Casey and Julie Voigt v. Coyote Creek Mining Company, LLC
Case No. RC-23-348

PSC Reclamation Division Memorandum

Memorandum

To: Zanna Brinkman, Jonathan Emmer, Jack Schuh
From: Monty Johnson
Date: September 30, 2022
Subject: MLJ response to “Comments of Casey and Julie Voigt, Objection to Mine Plan, and Request for Informal Hearing

Figure 1: GPS point tracklog of the inspection route (black) and the permit area (orange).

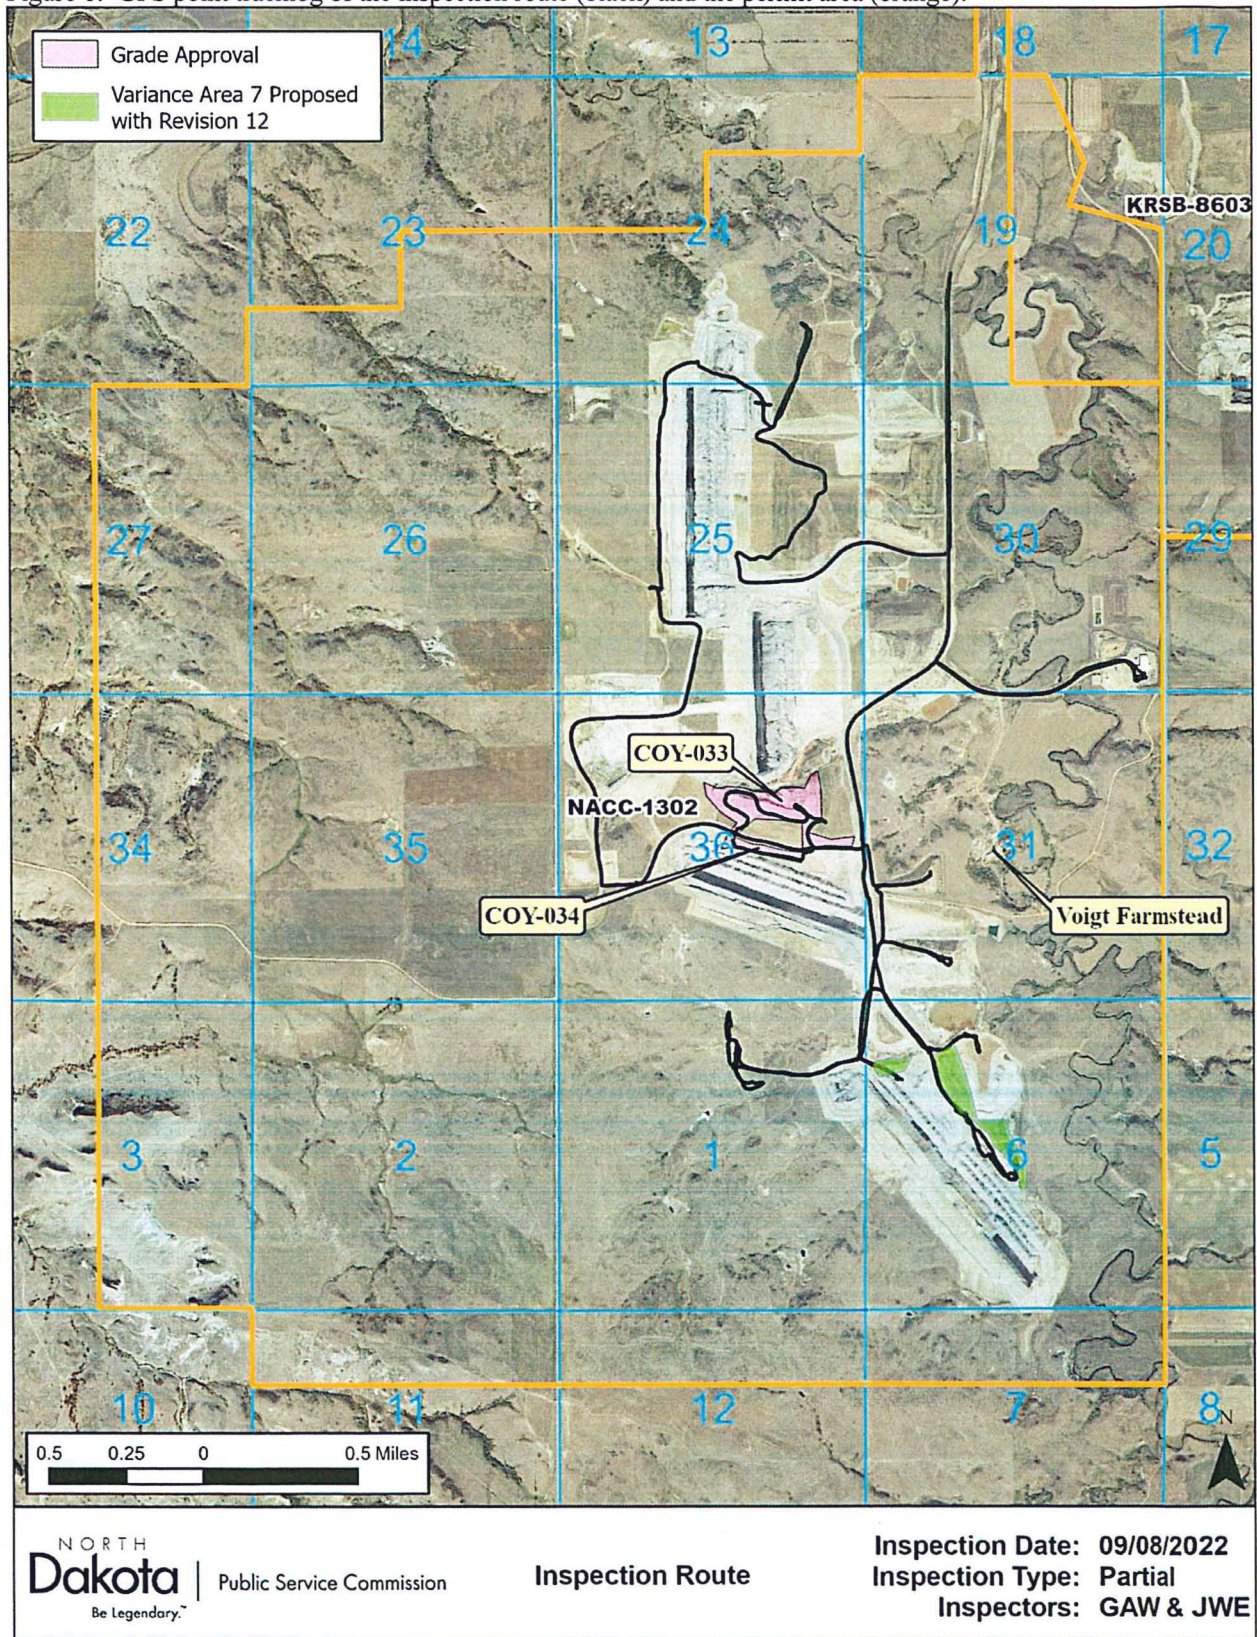
Backfilling and grading appeared contemporaneous or in compliance with plans approved in the permit. The area associated with proposed Variance Area No. 7 with Revision No. 12 was inspected. This area is located primarily in the NW¼ of Section 6. Most of the coal was removed from this area in 2019 with a small portion of coal removed in 2020. This variance area has been rough graded except for a spoil peak or pile immediately south of sediment pond P06-03. The surface of the spoil on this proposed variance area appears to consist of heavy clay soil that is very hard when dried and it does not appear that this spoil

material is susceptible to wind erosion; however, it may be highly susceptible to water erosion. There was no evidence of wind erosion has occurred on the spoil in this area. Additionally, no wind erosion was observed occurring during this inspection with winds gusting up to 26 mph. Scattered Russian thistle and kochia plants have established on the rough graded spoil.

Grade approval requests COY-033 and COY-034 in Section 36 of Permit NACC-1302 were inspected. The topography or surface contours of both areas conform to the topography approved in the permit and the surface is generally smooth and ready for subsoil respread. Mr. Sailer was reminded that steep slopes must be scarified prior to subsoil respread to reduce the potential for soil slippage. Mr. Sailer indicated that CCMC was planning to respread grade approval COY-033 beginning at the lowest elevation and moving upslope to reduce compaction.

Portions of grade approval requests for COY-033 and COY-034 include land along the quarter line between the NE $\frac{1}{4}$ and SE $\frac{1}{4}$ of Section 36. The approved post-mining land use map indicates that a permanent access road is to be constructed on this quarter line. CCMC staff verbally indicated that the Mine, Mercer County, and Mr. Casey Voigt are in the process of revising the agreement regarding the location of this access road. Reclamation Division staff indicated that CCMC may need to provide a written account of the changes planned regarding this road prior to grade approval. This issue should also be addressed in each grade approval request to explain why a road is not shown on these grade approval requests.
